Item 7.**Development Application: 8-24 Kippax St, Surry Hills - D/2023/1162****File No.:** D/2023/1162**Summary**

Date of Submission:	The application was lodged on 9 January 2024. Amended architectural drawings and an amended Civil Engineering report were provided on 24 April 2024.
Applicant/Owner:	Canva Pty Ltd.
Architect:	Cox Architects
Planning Consultant:	Ethos Urban
Cost of Works:	\$56,506,656
Zoning:	The site is located within the MU1 Mixed Use Zone. The proposed development relates to the adaptive re-use of an existing building for commercial office uses, which is a permissible land use within the zone.
Proposal Summary:	<p>The proposal involves the adaptive reuse of an existing 10 storey commercial building for ongoing office uses. The proponent is Canva, an online design and visual communications company. Canva are also the site owner.</p> <p>The proposal involves:</p> <ul style="list-style-type: none">• retention of the majority of existing building structure with insertion of new structural bracing, reinforcing of existing fabric and new fenestration;• demolition and re-construction of the lift and circulation core to the eastern edge of the building;• relocation of an

Figure 15: Amendments made to the scheme, including repurposing of a pop-up retail space as a two vehicle loading dock (red arrow), and reduction of door widths at Sophia Street (blue arrows). Proposed flood gates and internal level changes to address flooding are clouded red.

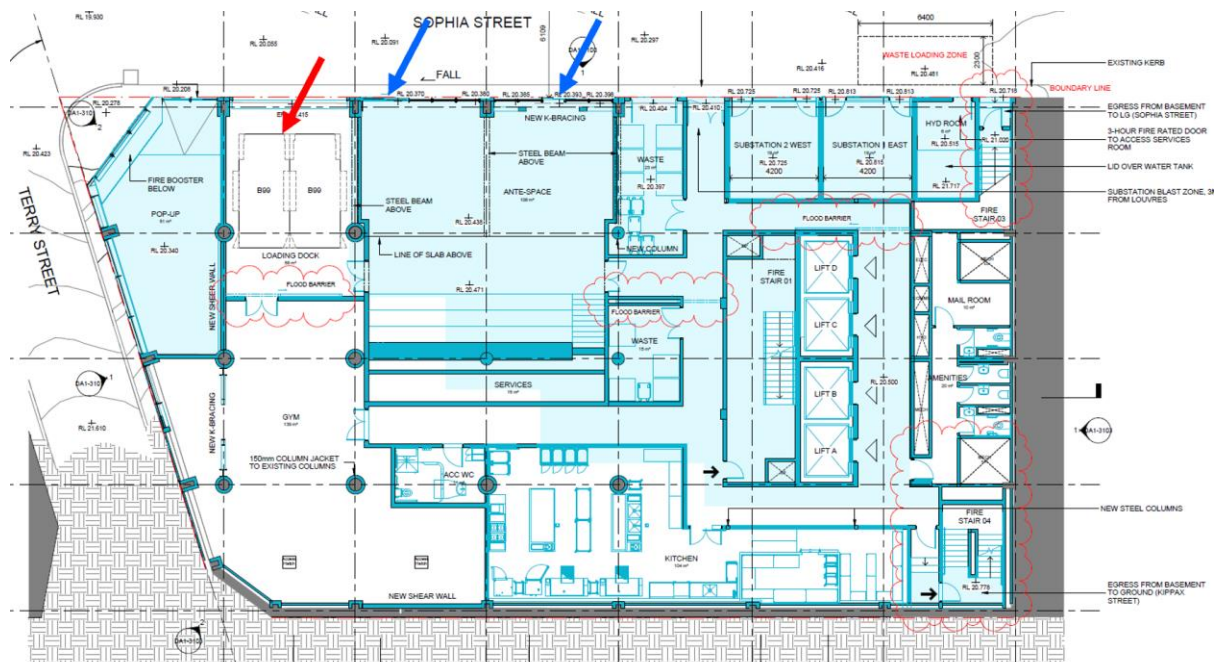
Amended architectural drawings have been provided showing a loading dock on Sophia Street and the deletion of bi-fold doors that would have extended over the property boundary at Sophia Street.

21. On 24 April 2024, amended architectural drawings were provided and an amended flood report was provided. The updated documents demonstrate that where finished floor levels do not satisfy recommended flood levels, that internal flood gates will be activated in the event of a flood (Figure 15 below). The flood gates will activate to recommended flood levels, with the intention of protecting the basement areas of the building.

Figure 34: Existing height of building, measured between Kippax and Sophia Streets (left). The building has a proposed maximum building height of 39.9m, measured from existing ground levels at the Sophia Street frontage (right).

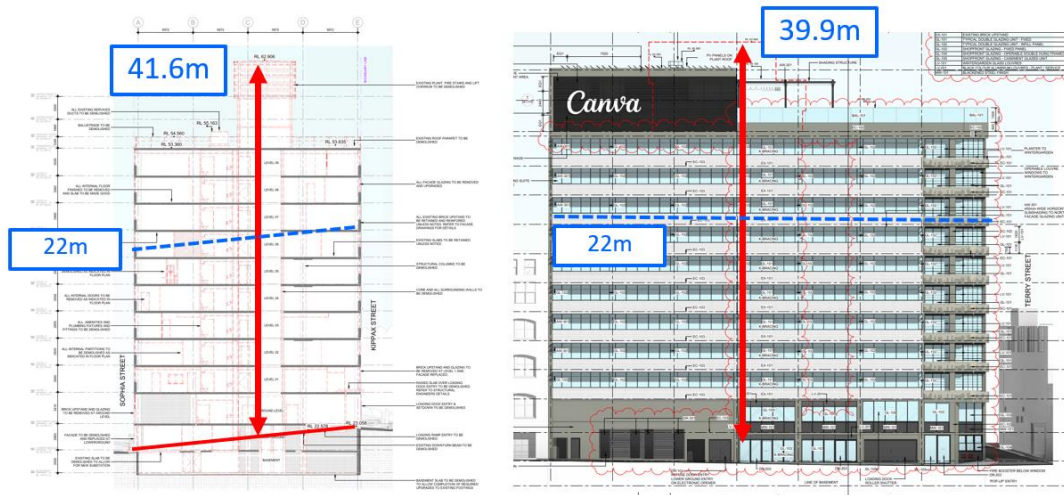
- 52. The site is subject to a maximum height of buildings development standard of 22m. The existing building has a height of approximately 41.6m and exceeds the 22m development standard by 19.6m (89%).
- 53. The proposed development includes the removal of the centrally located roof plant and the construction of new structure at the roof level containing plant and amenities. The new structure proposes a new maximum height of building of 39.9m, as measured at the Sophia Street boundary.
- 54. The proposal exceeds the 22m height of buildings development standard by a maximum of 17.9m (81%), which is a reduction in building height of approximately 1.7m as compared to the existing condition of the site.

59. The written statement provided by the applicant has sufficiently justified that strict numeric compliance with the height of buildings development standard specified by clause 4.3 of SLEP2012 is unreasonable and unnecessary pursuant to Clause 4.6(3)(a).
60. With regard for the issues raised at Clause 4.6(3)(b) of SLEP2012, the applicant's written request has adequately demonstrated that there are sufficient environmental planning grounds to justify the contravention of the floor space ratio development standard in the circumstances of the case. The applicant's demonstration is agreed and is articulated above.

Figure 35: Massing plans comparing the existing condition of the site (left) and proposed works (right), as viewed from the opposite side of Kippax Street looking north-west (New Limited car park) and from Elizabeth Street, looking east.

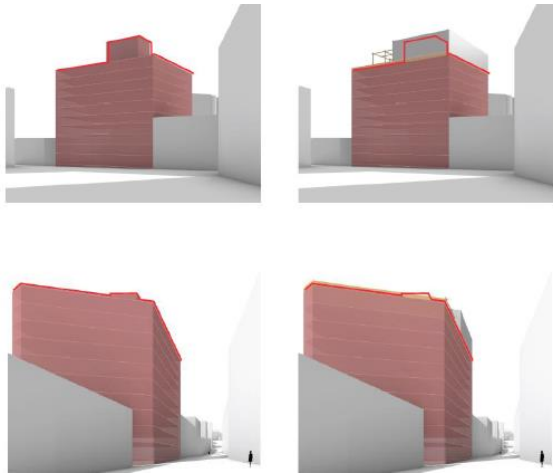
- (iv) the parts of the building that exceed the standard will not radically transform the built form or surrounding character as viewed from key vantage points (Figure 35 above); and

For the reasons provided above the requested variation to the height of buildings development standard is supported as the applicant's written request has adequately addressed the matters required to be addressed by cl 4.6 of the Sydney Local Environmental Plan 2012 and the proposed development would be in the public interest because it is consistent with the objectives of the height of buildings development standard and the MU1 Mixed Use Zone.

Figure 37: amended drawings show doors opening onto Sophia Street have been reduced to narrower apertures with a combined width of 3m.

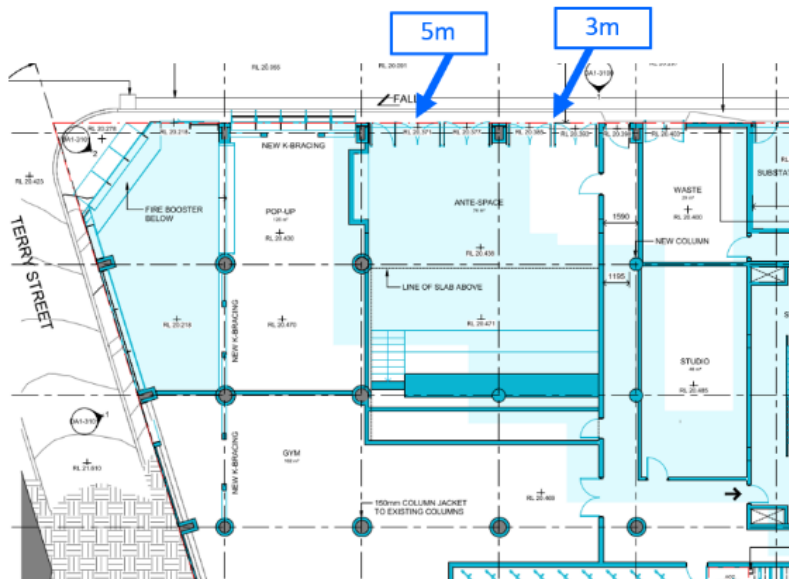
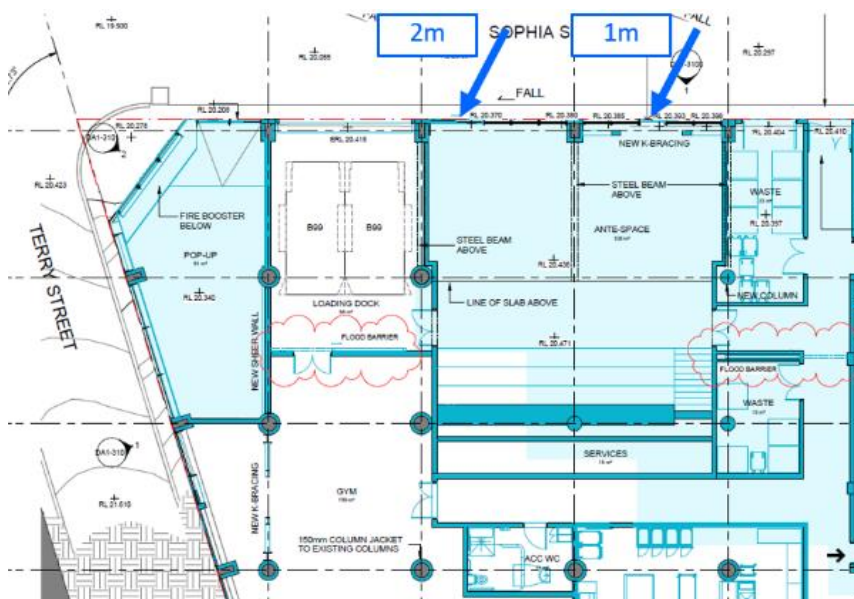
- (b) bi-fold doors opening over Sophia Street have been deleted and replaced by regular windows, as they were at risk of being damaged by passing trucks. A design modification condition is recommended, requiring similar vertically opening bi-fold doors extending over the Kippax Street footpath to also be re-designed;

73. Amended ground level drawings demonstrate doors for the 'Town Hall' ante-space at the Sophia Street frontage have been substantially reduced in width. Originally, full width doors provided for the footway of Sophia Street to function as a 'break out space' for occupants of the building (Figures 36 and 37 below).
74. The use of Sophia Street itself as a break out space was not supported by Council's planners on the grounds of poor pedestrian safety, amongst other things. Vehicles turning left from Terry Street into Sophia Street have a limited line of site and would not generally expect pedestrians to be on the roadway within a service lane.

75. Notwithstanding the redesign of the doors, a condition is recommended that the roadway of Sophia Street is not suitable for events associated with the site. A condition is also recommended requiring the preparation of a plan of management relating to the use of the Town Hall ante-space.
76. The management plan is required to address recommendations made by the amended acoustic report, including that doors and windows to Sophia Street must be kept closed at specified times to achieve required noise criteria. The intentions of requiring a management plan are to maximise pedestrian safety and to ensure the function of the Town Hall area will not have any significant impacts for the residential amenity of neighbouring buildings.

Figure 47: Section drawings showing projecting planter boxes (Kippax Street and Terry Street).

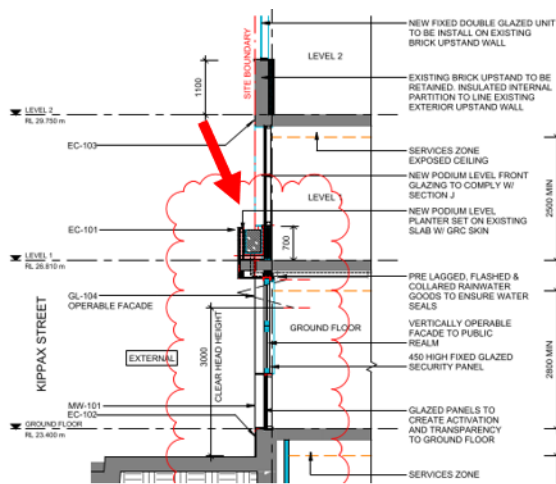
103. The level 1 planter boxes are proposed to extend over the property boundaries of Terry and Kippax Streets by approximately 450mm and are elevated above the footpath level by a minimum of 3.7m.

113. A condition is recommended that a Positive Covenant must be registered on the title of the subject lot, requiring the lot owner to maintain all projecting planters in perpetuity. The Positive Covenant must indemnify Council against any claims and damages, will indemnify Council and provide for the maintenance, upkeep, and repair of the planter boxes.

Figure 50: Extract from deposited plan, registered at NSW Land Registry Services in 1972, with the intention of dedicating the splay corners (limited in stratum).

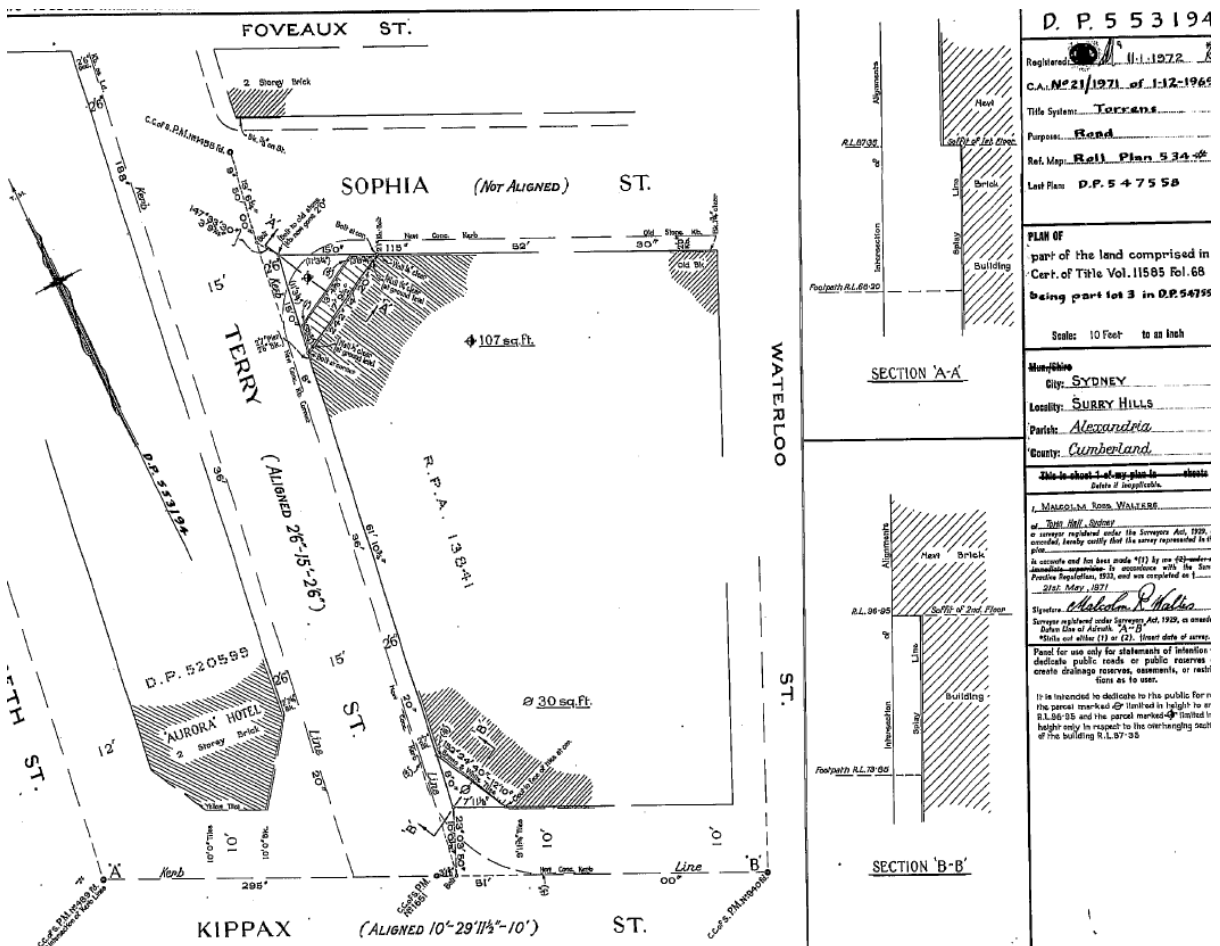
- 127. Council's surveyor advises that the City's records indicate that a deposited plan (DP 553194) was registered at NSW Land Registry Services in 1972. The deposited plan describes the intention of the site owner to dedicate the splayed areas at the western edge of the site as public road (limited in stratum). The splayed edges are at the corner of Terry Street, Kippax Street and Sophia Street (Figure 50 below).

- 128. Council's surveyor advises that it is unclear whether the splayed corners in stratum were formally dedicated to Council (by gazettal or other means) at the completion of construction of the building.

- 129. To address this issue, a condition is recommended that a 'plan of redefinition,' redefining the boundaries of the subject site shall be carried out, with the work to be done prior to the issue of a construction certificate. The final 'plan of redefinition' will be required to be registered at NSW Land Registry Services prior to the issue of an occupation certificate, formalising the dedication of the areas. This issue has been discussed with the proponent during assessment.
